MIL-A-82451(OS)
Amendment 2
3 July 1969
Superseding
Amendment 1
24 October 1966

MILITARY SPECIFICATION

ACTUATOR ASSEMBLY TEST SET

(For Torpedo Mk 46 Mod 1)

Figure 1. Rate Output

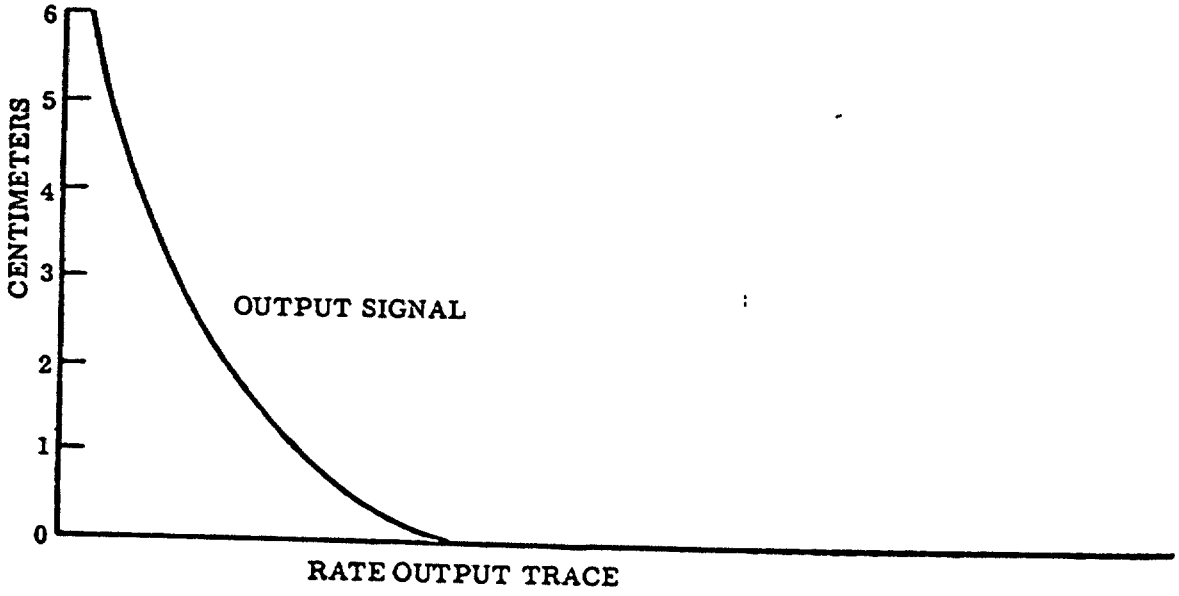
Page 11, Figure 1: Replace with new Figure 1 attached.
